APPLICATION NO.	FILING DATE	FIRST NAMED INVENTOR	ATTORNEY DOCKET NO.	CONFIRMATION NO.
10/521,692	05/13/2005	John G Mancino	1872	2171
24264 7590 12/29/2006 MARTIN & HENSON, P.C. 9250 W 5TH AVENUE SUITE 200 LAKEWOOD, CO 80226			EXAMINER DUCKWORTH, BRADLEY	
			ART UNIT 3632	PAPER NUMBER
SHORTENED STATUTORY PERIOD OF RESPONSE			MAIL DATE	
3 MONTHS			12/29/2006	
			DELIVERY MODE PAPER

Office Action Summary	Application No. 10/521,692	Applicant(s) MANCINO ET AL.	
	Examiner Bradley H. Duckworth	Art Unit 3632

DETAILED ACTION

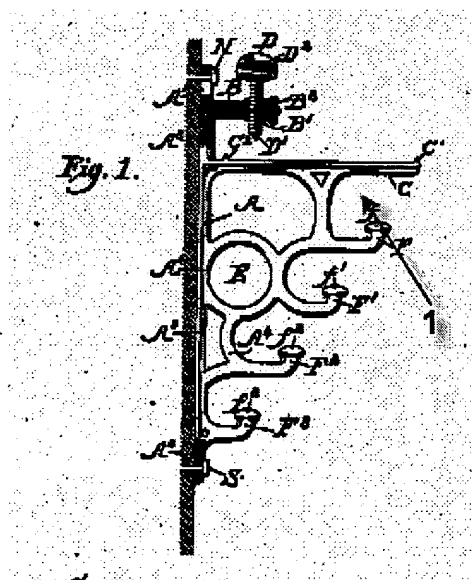
Claims 1,2,4-7, 14-18, 20-25, 29, and 31 are rejected under 35 U.S.C. 102(b) as being anticipated by Heysinger(US000564519). Referring to annotated figure 1 below,

Heysinger teaches a bracket with a base(A) that has a J-shaped mounting portion(B+D) used to mount a shelf, with an elongate beam portion(C) with a planar web portion(E) with a plurality of holes with a slot(1) formed on a forward edge, with a flange(C) on the beam section with a width greater then the web thickness but less then the web height, with a hook structure(F2) extending forward of said base and web, where the hook structure is an elongate arm spaced from said beam portion with a arcuate free end that curves toward said beam portion, with a pad(f2) on the free end forming a rearward extending lip.

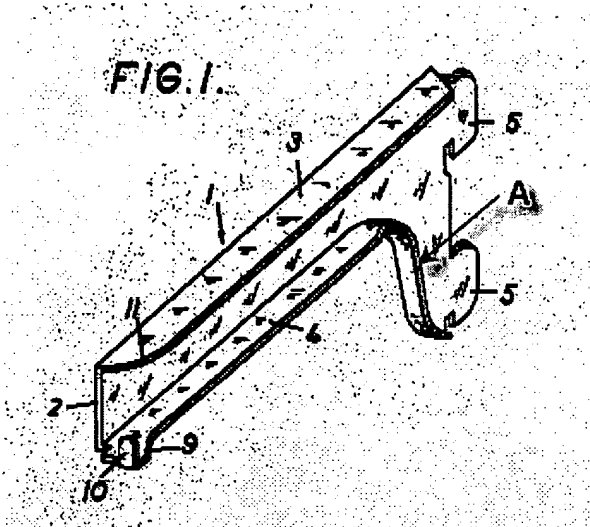
Claims 1,2,3,9,and 10-13 are rejected under 35 U.S.C. 102(b) as being anticipated by Bjerke(US003185426). Referring to annotated figure 1 below, Bjerke teaches a bracket with a base with a j-shaped mounting portion(Upper 5) and a latch structure(lower 5), with an elongate beam member with a web portion(2) with a rearward reinforcement rib(A) with a first flange(3) and a second flange on the lower edge(4) of the web where the second flange width is less then that of the first flange(see

fig 2) but is still greater than the web thickness, where the first flange length is greater than that of the second flange, where the second flange has opposite edges that converge to hook structure (10) that extends forward of said base.

FIG. 3

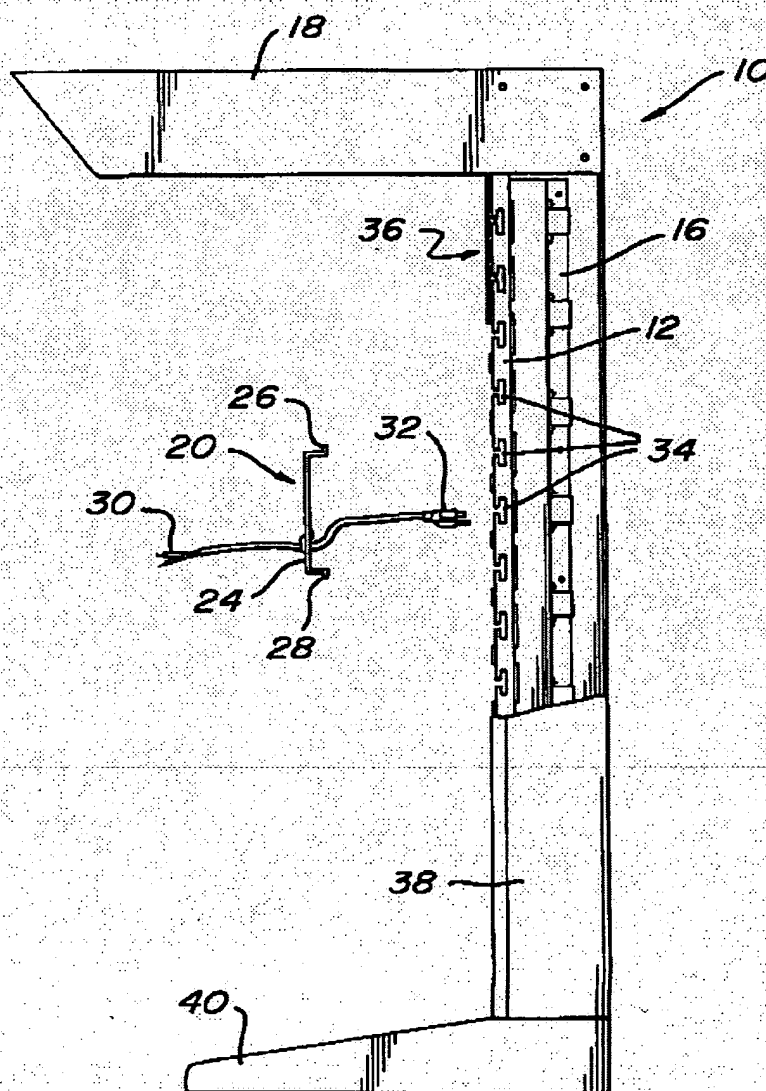
Claims 32,38,39 and 40 are rejected under 35 U.S.C. 103(a) as being unpatentable over Portner, in view of Bjerke in view of Heysinger as applied to claim 21 above. Referring to Figure 3, Portner teaches a lighting fixture display comprising a support member(32) in a vertical orientation relative to and attached to a support structure(10), as well as brackets to hold lighting devices and their wires. However Portner does not disclose the use of brackets comprising a base, with an elongate beam portion with a flat upper surface, a web portion, and an elongate support arm spaced apart from said beam, such as the bracket created with the modified bracket of Bjerke of claim 21 as detailed above. It would have been obvious to replace the brackets of Portner with a pair of brackets of Bjerke, because the modified brackets of Bjerke would allow for the support of a large range of items, including a shelf and any item that could be mounted on a shelf, such as larger light devices. In regards to claim 38, applicant admits cable connectors are known in the art, and it would have been
